Well Name: RED HILLS UNIT	Well Location: T25S / R33E / SEC 33 / NWNE /	County or Parish/State:
Well Number: 104H	Type of Well: OIL WELL	Allottee or Tribe Name:
Lease Number: NMNM05792	Unit or CA Name:	Unit or CA Number:
US Well Number: 3002551932	Well Status: Approved Application for Permit to Drill	Operator: CIMAREX ENERGY COMPANY

Sundry ID: 2768283

Type of Submission: Notice of Intent	Type of Action: APD Change
Date Sundry Submitted: 01/04/2024	Time Sundry Submitted: 02:50
Date proposed operation will begin: 03/01/2024

Procedure Description: Cimarex Energy Company respectfully requests the following drilling and directional changes be made to the existing and approved APD for the following well: Red Hills Unit 104H 1. Casing design change - Long String to Liner. 2. New bottom hole location. See attached.

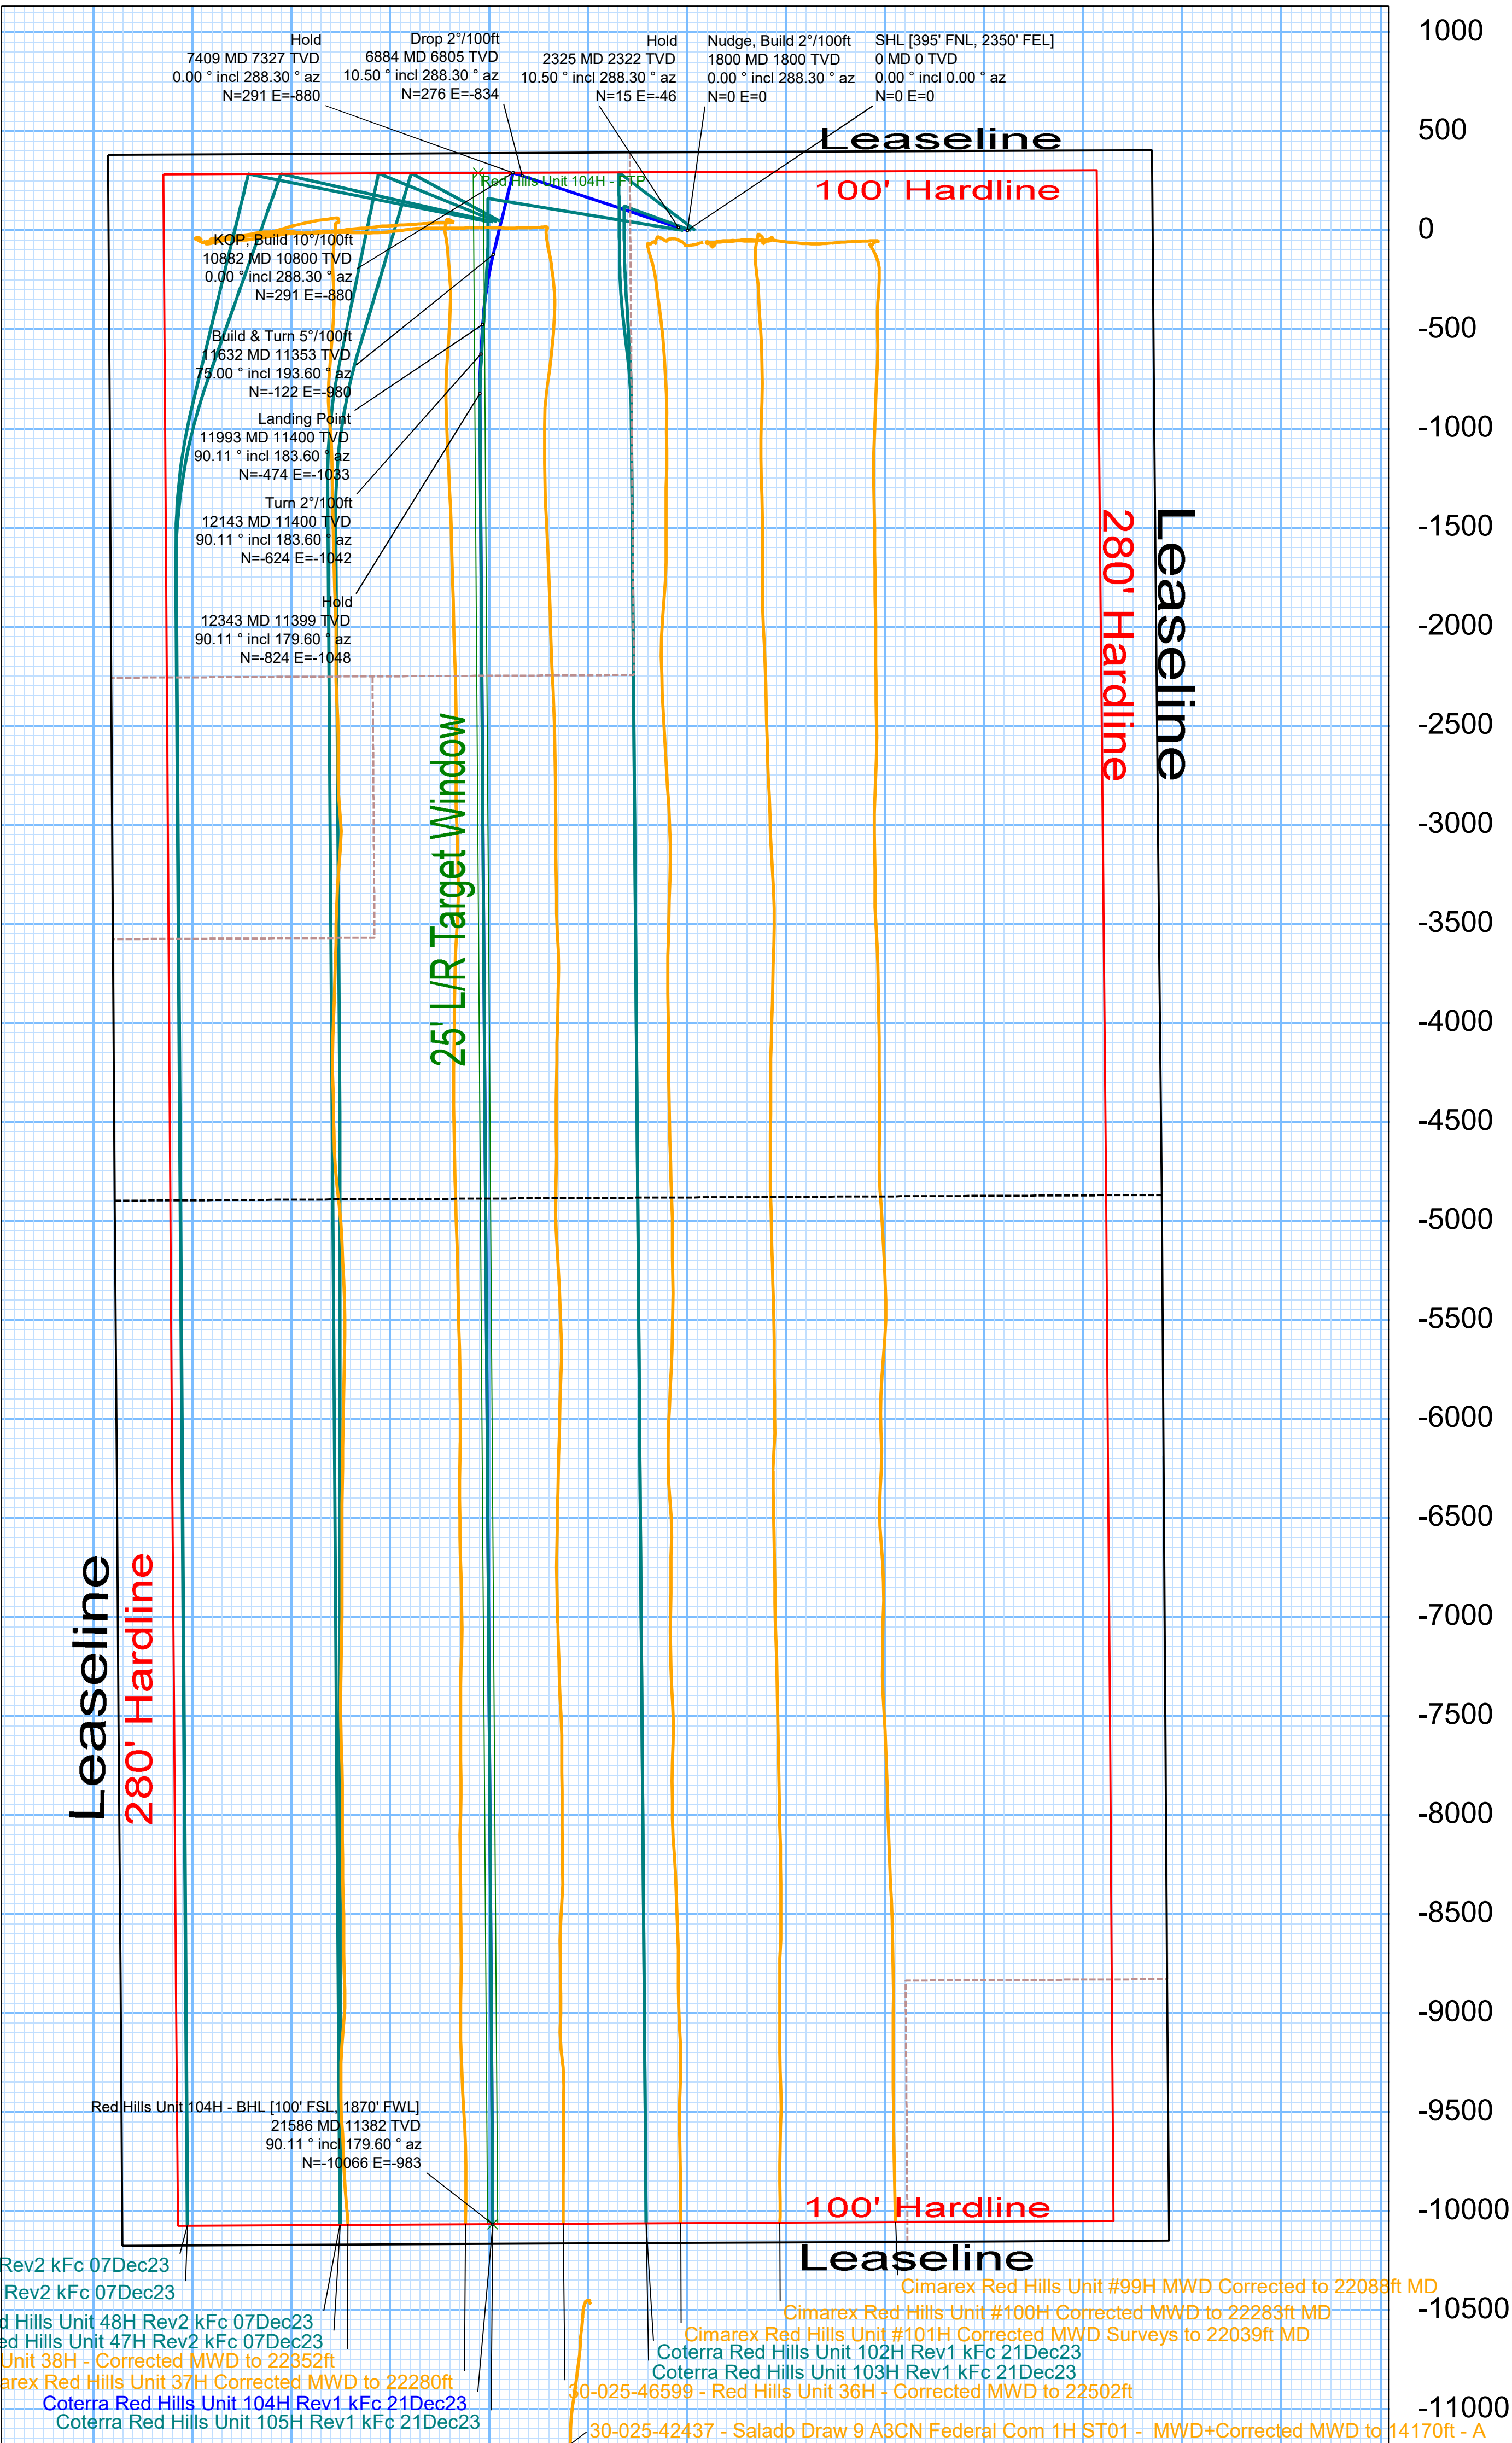
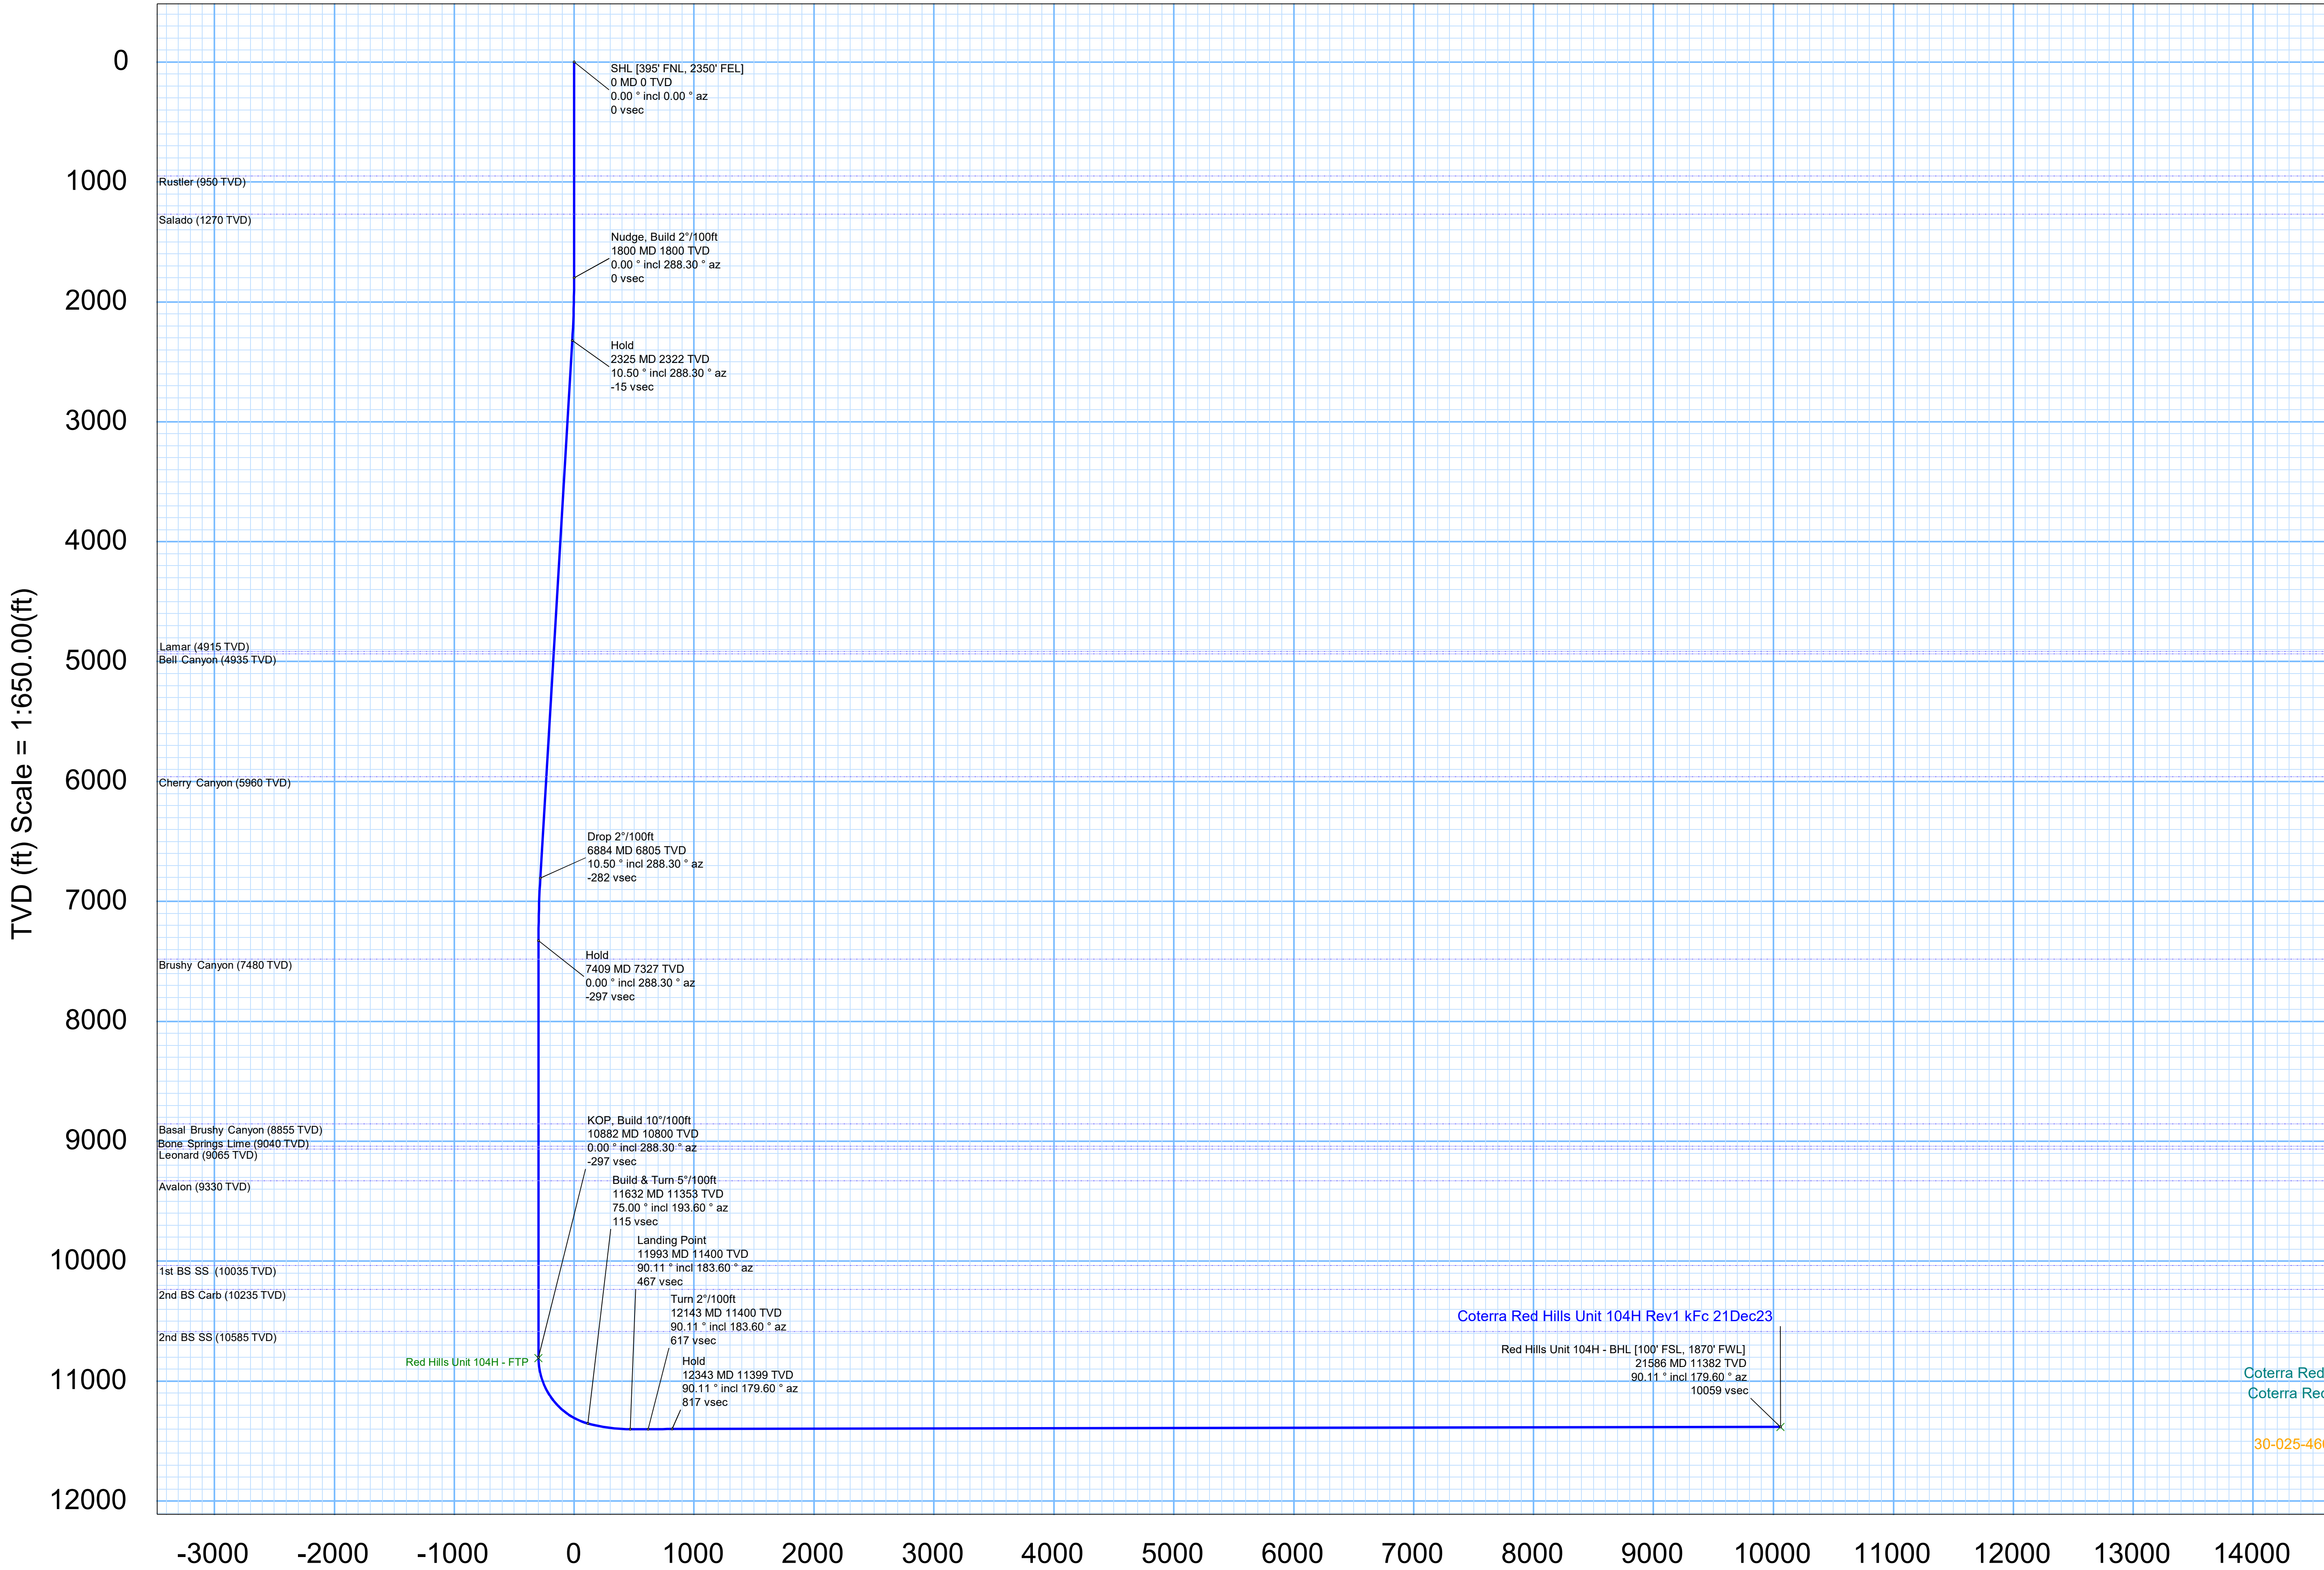
Critical Point	MD	INCL	AZIM	Critical Points	TVD	VSEC	N(+)/S(-)	E(+)/W(-)	DLS
SHL [395° FNL, 2350° FEL]	0.00	0.00	0.00	0.00	0.00	0.00	0.00	0.00	0.00
Rustler	950.00	0.00	288.30	950.00	0.00	0.00	0.00	0.00	0.00
Salado	1270.00	0.00	288.30	1270.00	0.00	0.00	0.00	0.00	0.00
Nudge, Build 2°/100ft	1800.00	0.00	288.30	1800.00	0.00	0.00	0.00	0.00	0.00
Hold	2325.09	10.50	288.30	2322.15	-15.39	15.07	-45.56	2.00	0.00
Lamar	4962.11	10.50	288.30	4915.00	-169.52	166.02	-501.88	0.00	0.00
Bell Canyon	4962.45	10.50	288.30	4935.00	-170.71	167.18	-505.40	0.00	0.00
Cherry Canyon	6024.91	10.50	288.30	5960.00	-231.64	226.86	-685.79	0.00	0.00
Drop 2°/100ft	6883.94	10.50	288.30	6804.64	-281.85	276.03	-834.44	0.00	0.00
Hold	7409.02	0.00	288.30	7326.79	-297.24	291.10	-880.00	2.00	0.00
Brushy Canyon	7562.23	0.00	288.30	7480.00	-297.24	291.10	-880.00	0.00	0.00
Basal Brushy Canyon	8937.23	0.00	288.30	8855.00	-297.24	291.10	-880.00	0.00	0.00
